**SCHEDULE OF AMENDMENTS TO
THE APPROVED MA ON SHAN OUTLINE ZONING PLAN NO. S/MOS/22
MADE BY THE TOWN PLANNING BOARD
UNDER THE TOWN PLANNING ORDINANCE (Chapter 131)**

**List of Representers in respect of
the Draft Ma On Shan Outline Zoning Plan No. S/MOS/23**

Draft Ma On Shan Outline Zoning Plan No. S/MOS/23 (Draft OZP)
Summary of Representations and Government Departments' Responses

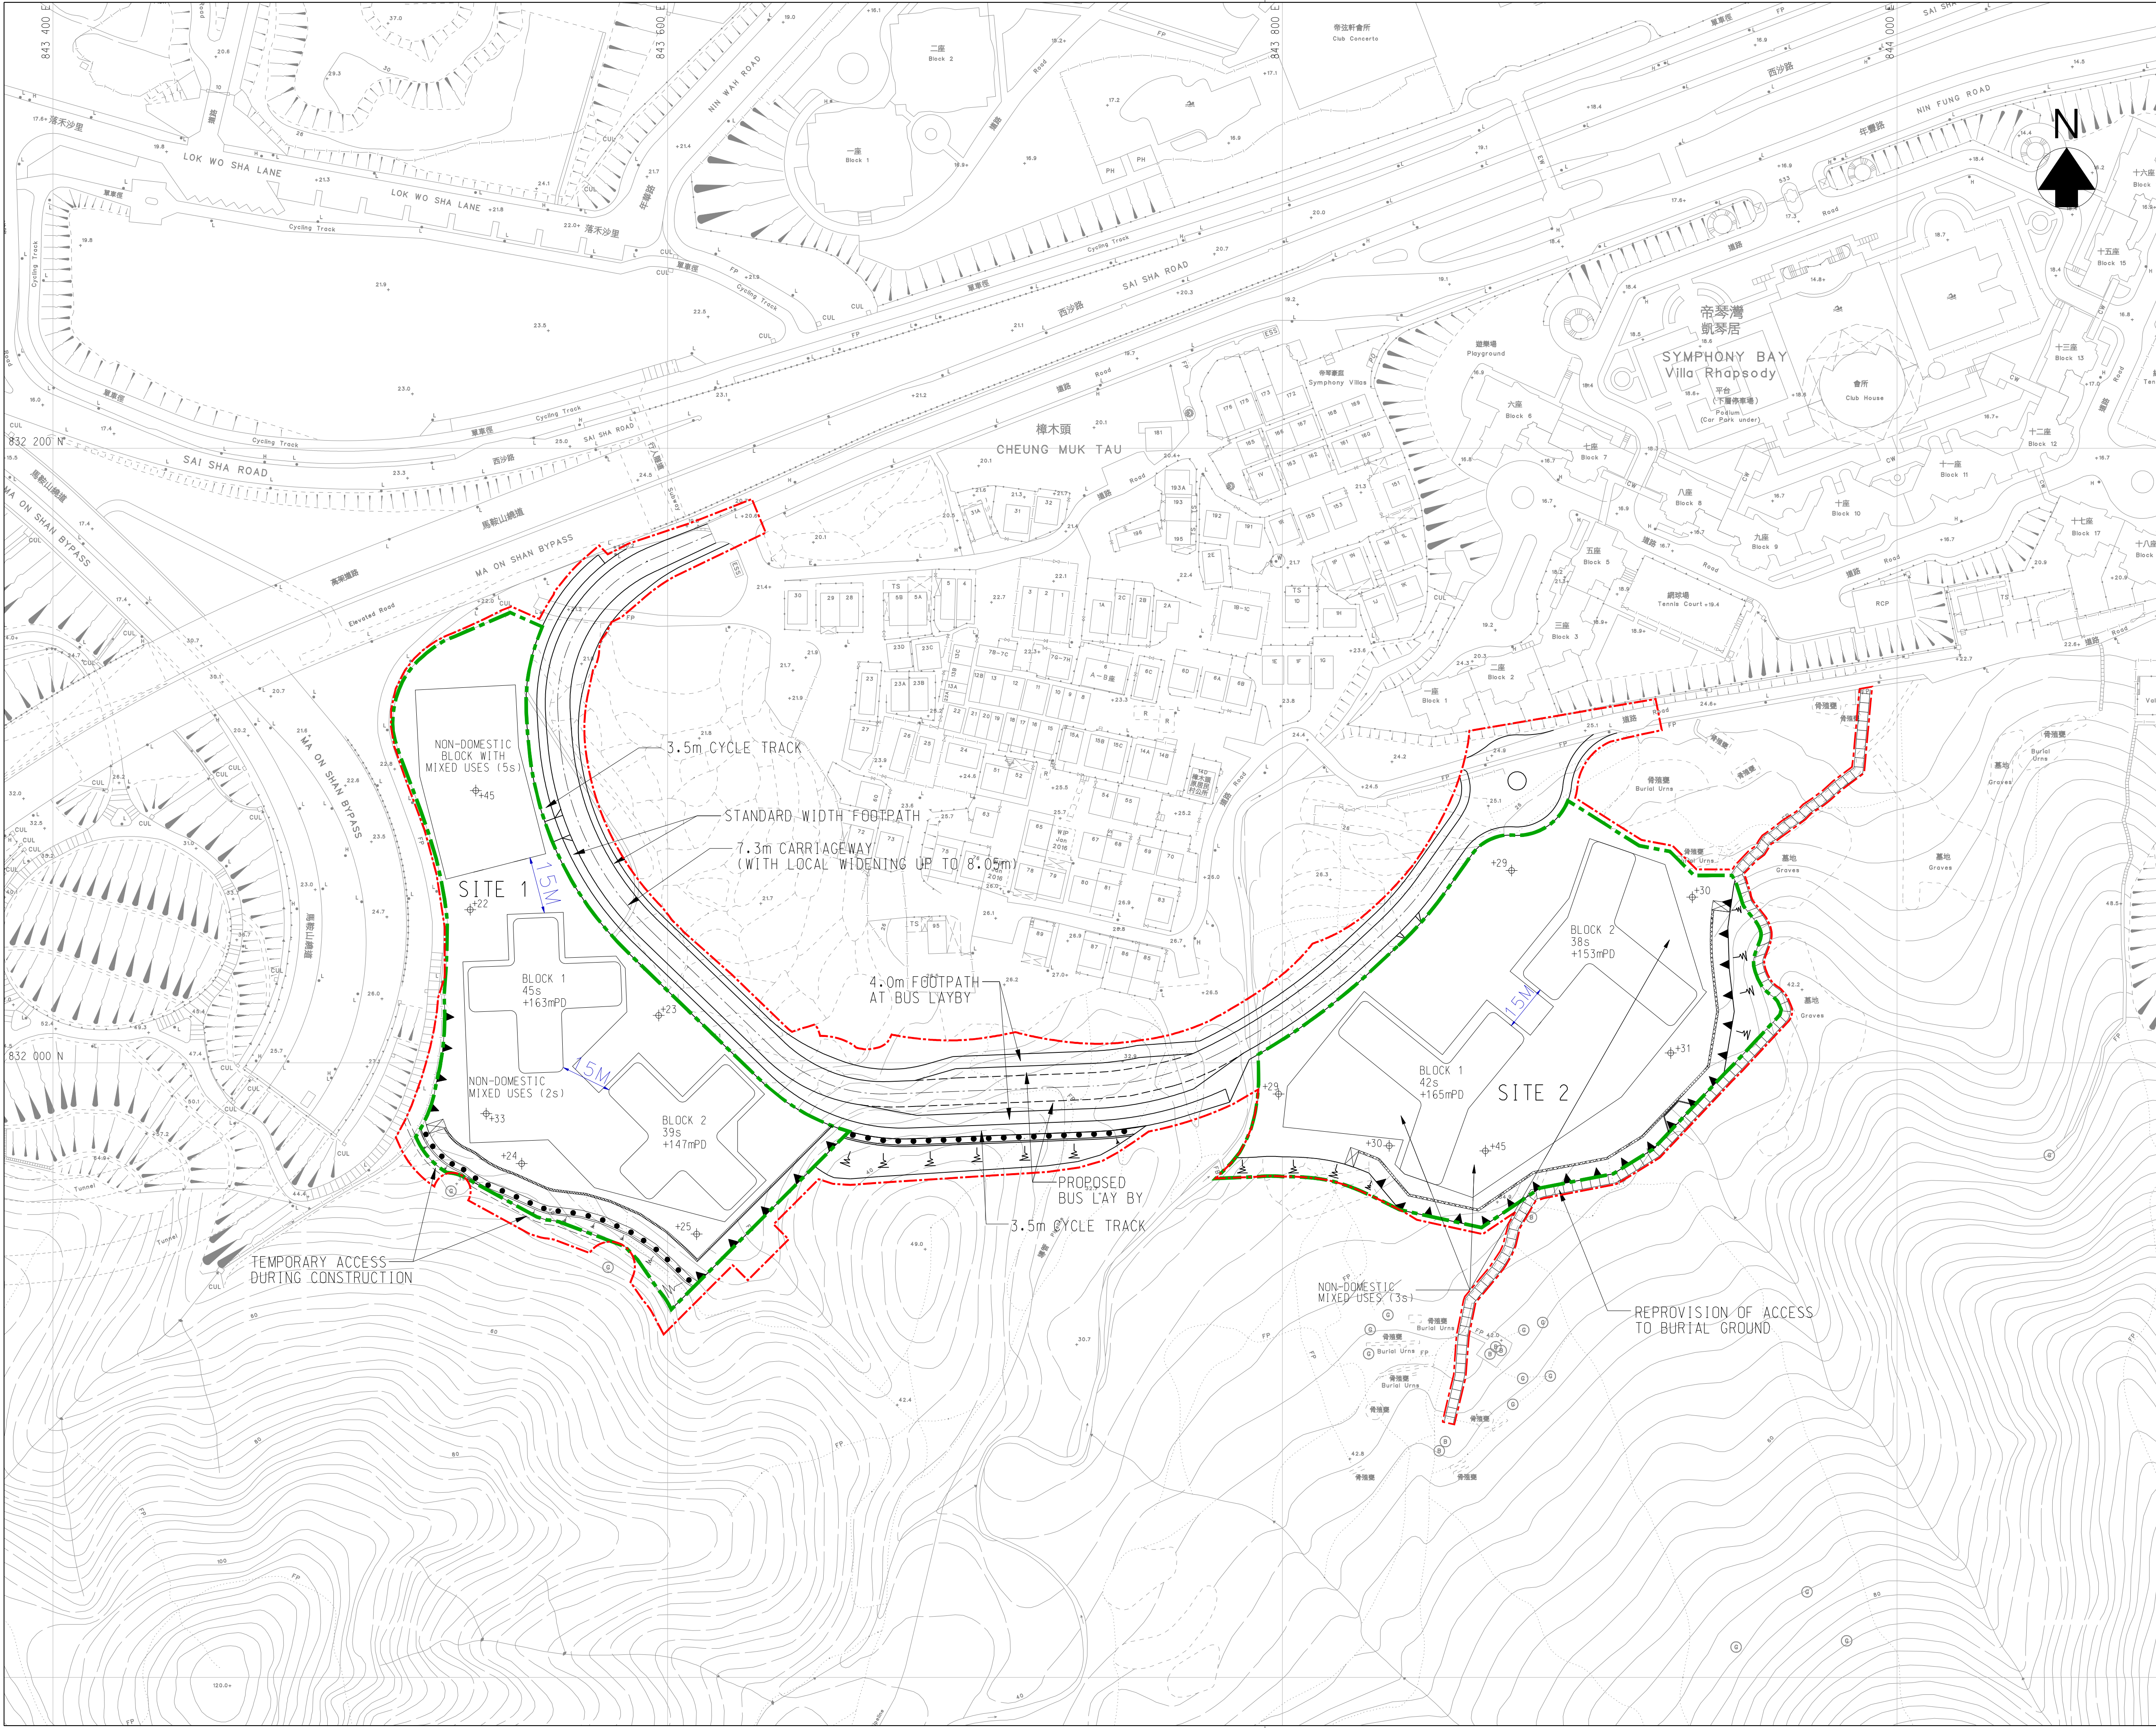
- In view of the close proximity with Shun Yee Sun Tsuen, there are concerns on how to avoid potential disturbance to the villagers including traffic, noise, air and water pollution, and visual aspects.
- It was suggested to improve the noise barrier along the roads in Ma On Shan to minimize the noise impact to residents caused by increasing traffic flow.
- According to the representative from PlanD, a Preliminary Environmental Review will be carried out for the development of Ma On Shan Tsuen. This appears to be contradictory with the RNTPC Paper No. 6/20, which mentions that the proposed development would not constitute a designated project under the Environmental Impact Assessment Ordinance. The methodology of evaluating the ecological value and biodiversity in Ma On Shan is unclear.

- Items D to G are located near the cultural heritage of Ma On Shan Mine including the 110 ML Portal and its associated structures, Shun Yee San Tsuen and the Mineral Preparation Plant. The government should put emphasis on conservation of cultural heritage in the meantime of development. There is a lack of protection measures for those historical structures.
